Parts Bulletin

PB25-021 8/18/25

Subject: Cord Assy Changed

Applicable Model: MFS 40/50/60A(W): 004715BE, MFS 75/90/100/115/140A(W): 005079BE

No.1,2 CORD ASSY

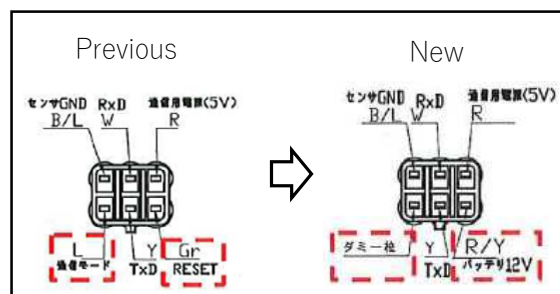
Reason(s) for Improvement / Change						
☐	Reinforcement	☐	Durability	☒	Dimension / Shape	☒
☐	Serviceability	☐	Weight Saving	☐	Material Change	☐
☐	Corrosion Resistance	☐	Drivability	☐	Parts Commonality	☐
Other						
Comment: Diagnostic connector changed

Diagnostic Connector

No.	Part Name	Previous Part Number	New Part Number	Qty.	Interchange-ability	Applicable Models
1	CORD ASSY	3KY-76110-4	3KY-76110-5	1	D	MFS 40/50A(W)
2	CORD ASSY	3UR-76110-0	3UR-76110-1	1	D	MFS 60A(W)
3	CORD ASSY	3UG-76110-0	3UG-76110-1	1	D	MFS 75/90/100/115/140A(W)
4	DIAGNOSTIC TOOL KIT	3SS-72920-1	3SS-72920-2	1	D	MFS 40/50/60A(W) MFS 75/90/100/115/140A(W)
5	EXTENSION CORD	-	3UG-76112-0	1	-	MFS 75/90/100/115/140A(W)

No.3 CORD ASSY

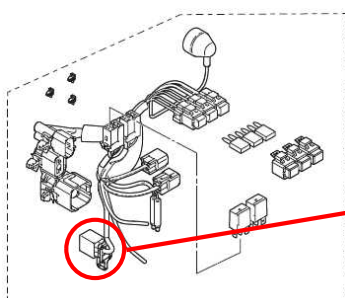
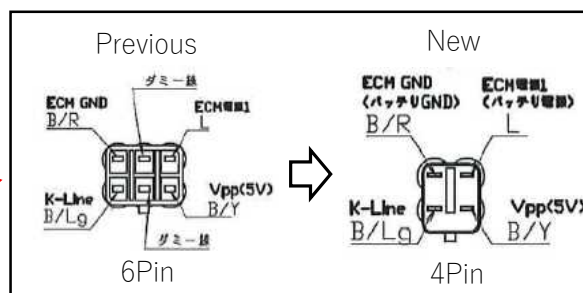
Diagnostic Connector

Due to a recent change in the code assy, a dedicated extension code is now required when using the diagnostic tool kit with MFS75–140A models manufactured since 2025.
